ADDENDUM NO. 1

ISSUE DATE: April 4, 2018

CRC College Center Expansion

LRCCD BID NO. 17021

SHEET NO:
E1.02

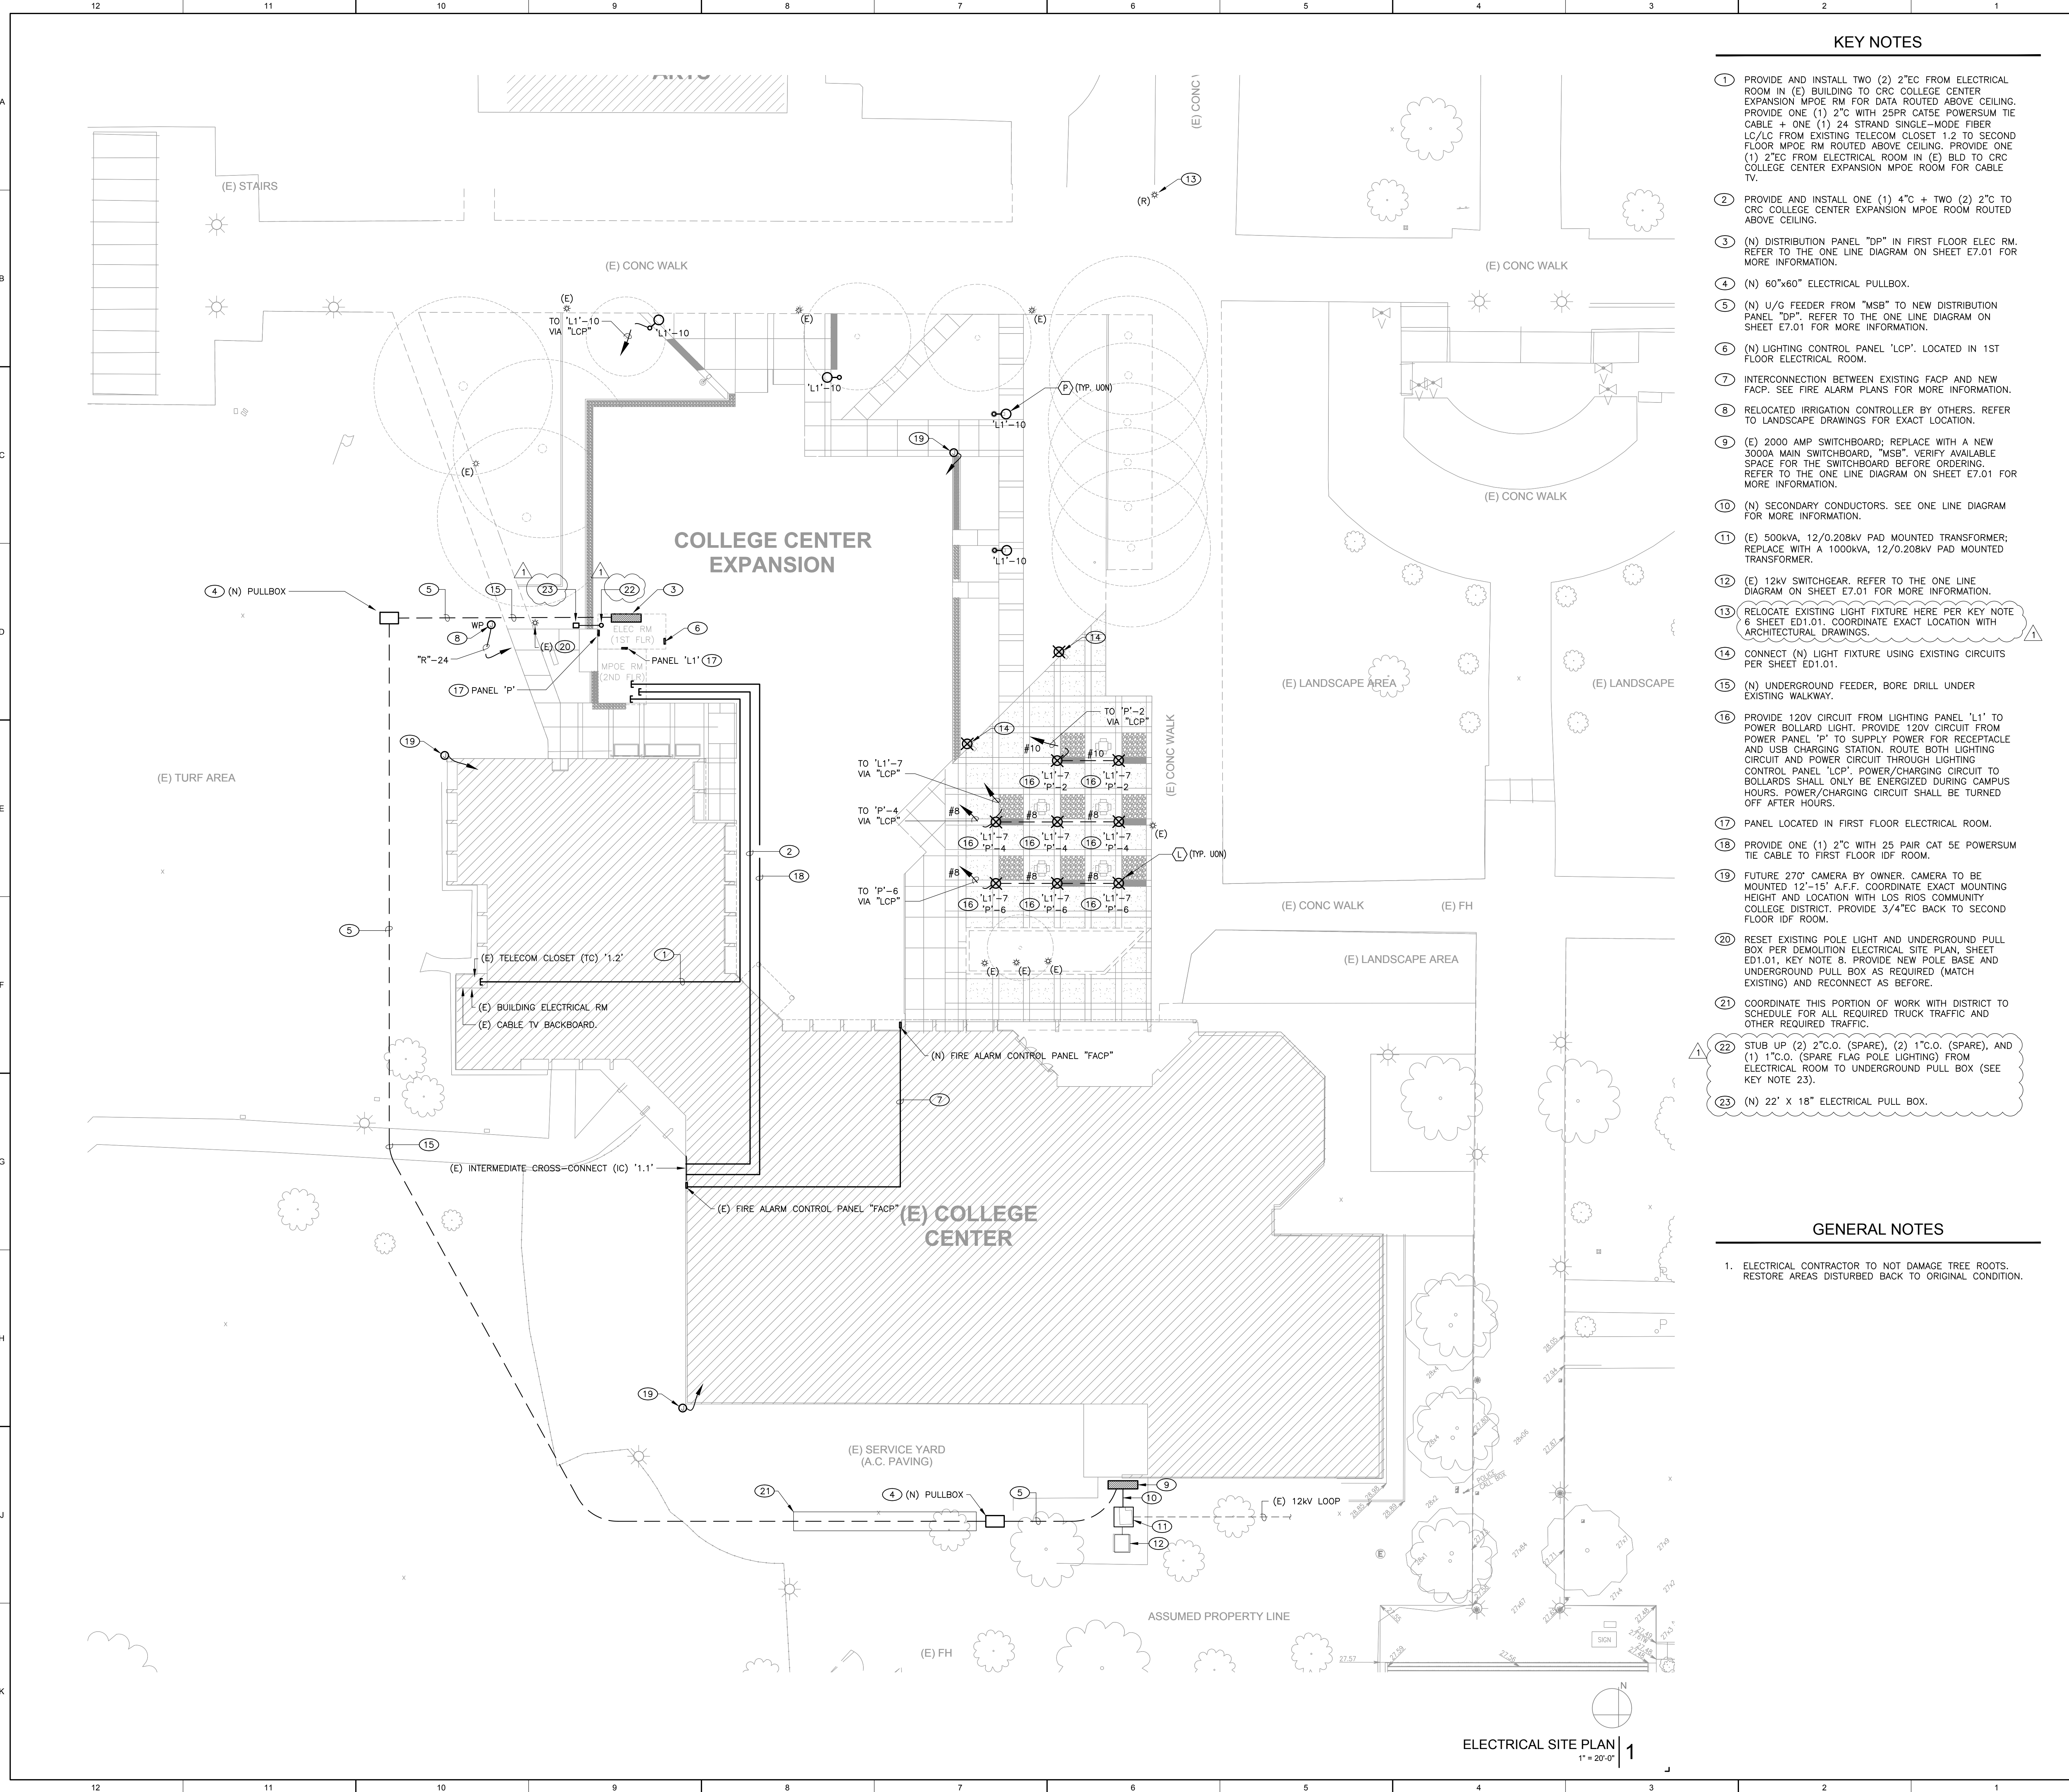
- E1.02 – Remove some sawcut areas and revised key note 6.
- E1.03 – Revised key note 13 for coordination.
- E2.01A – Revised key note 8 for coordination with C5 & K5/A9.82. Added interface note with EMS for lighting control panel LCP.

SHEET NO:
E2.03

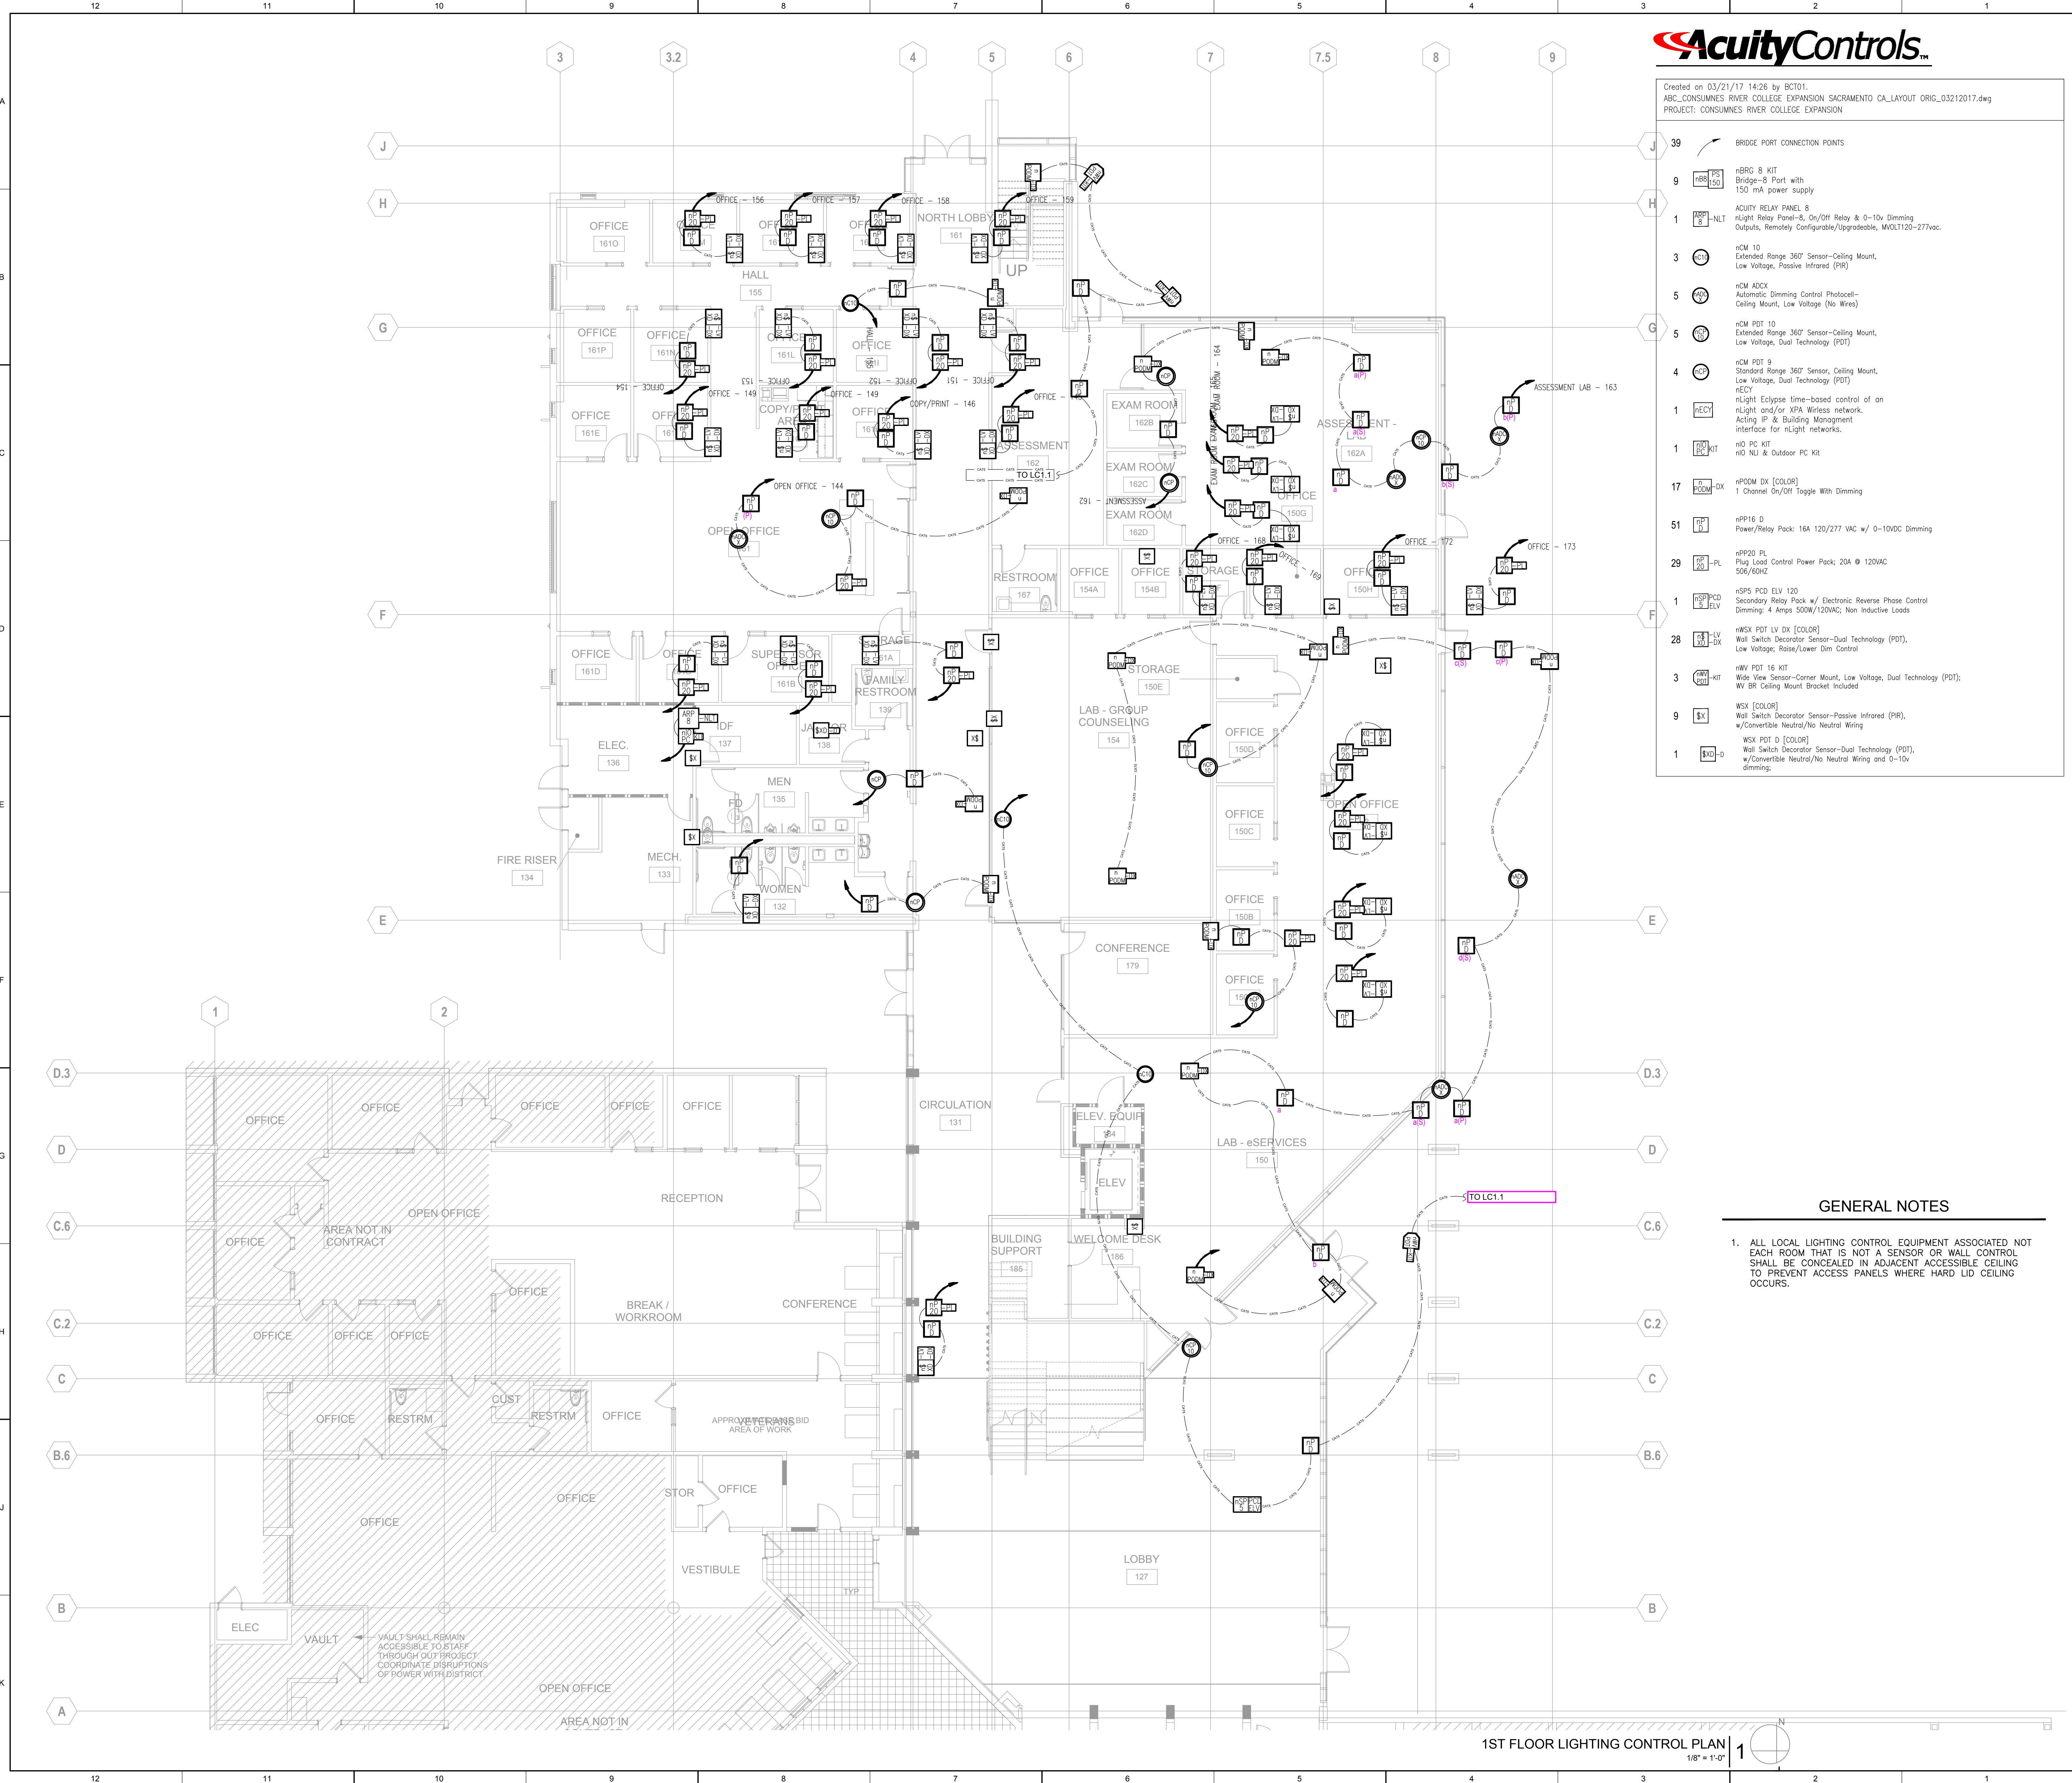
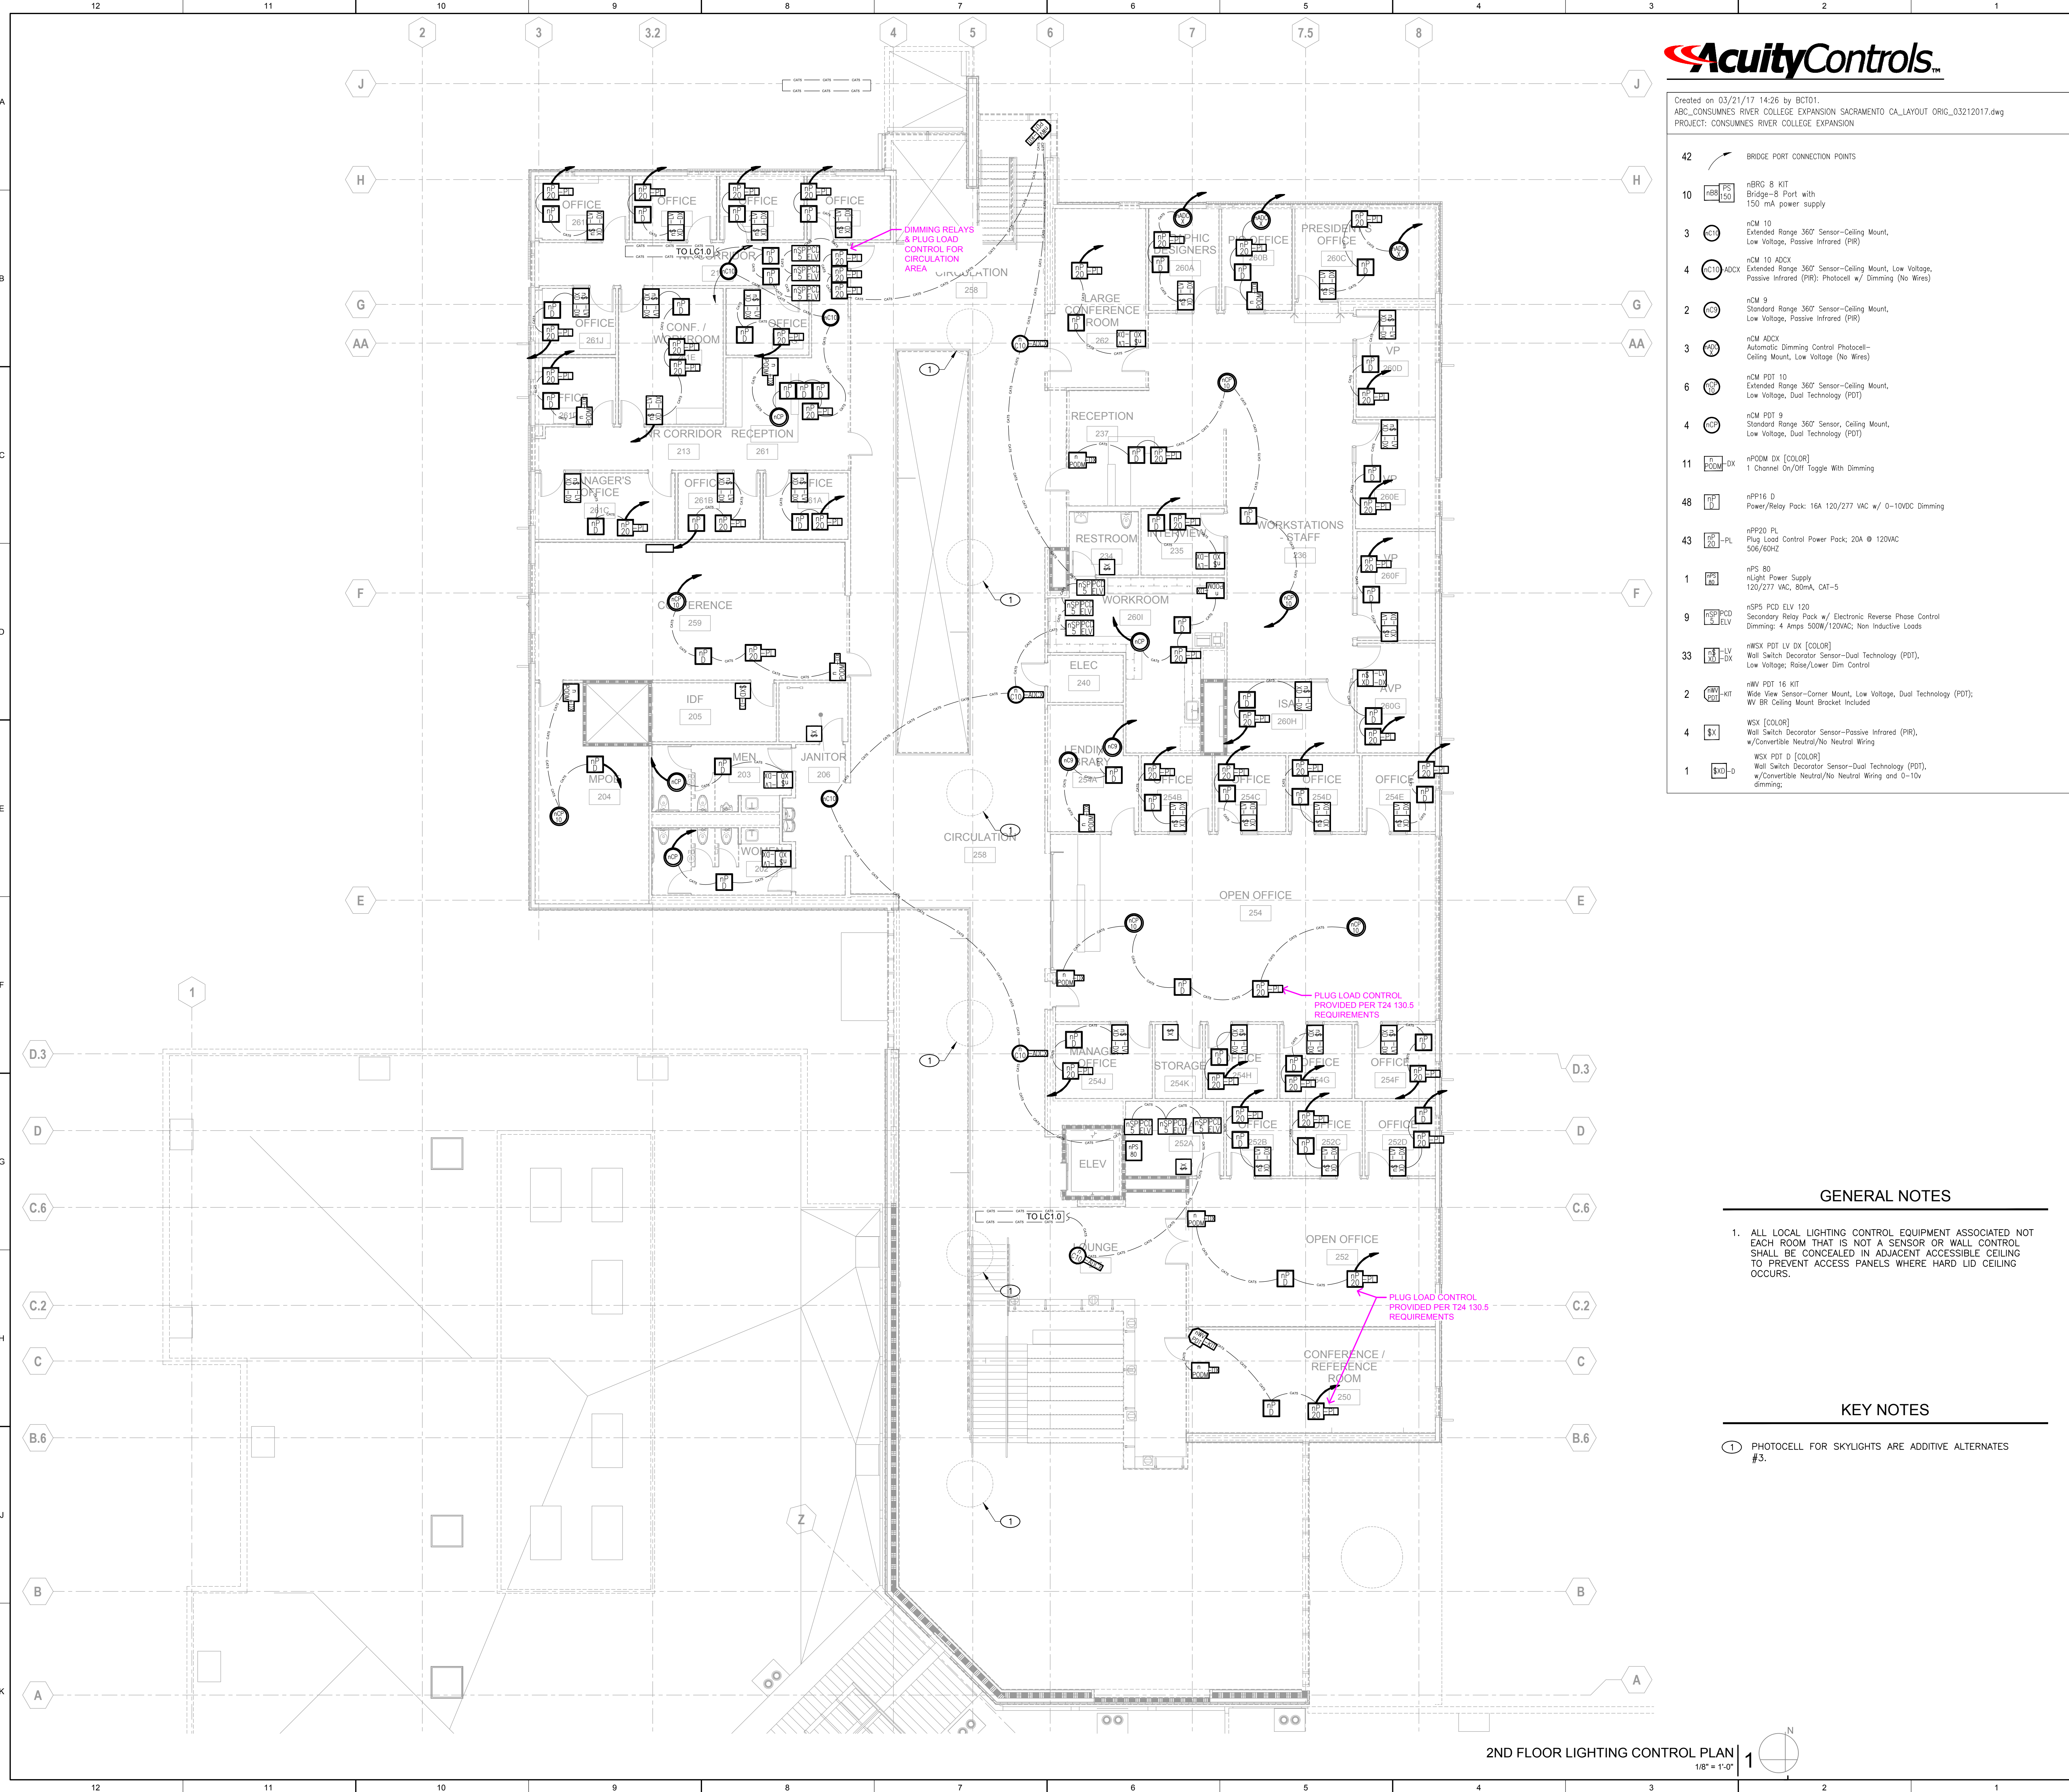
- E2.01B – Revised remodel area
- E2.02 – Added edge lit signs and added exterior downlight at southeast entry
- E2.03 – Added general note and modified device locations
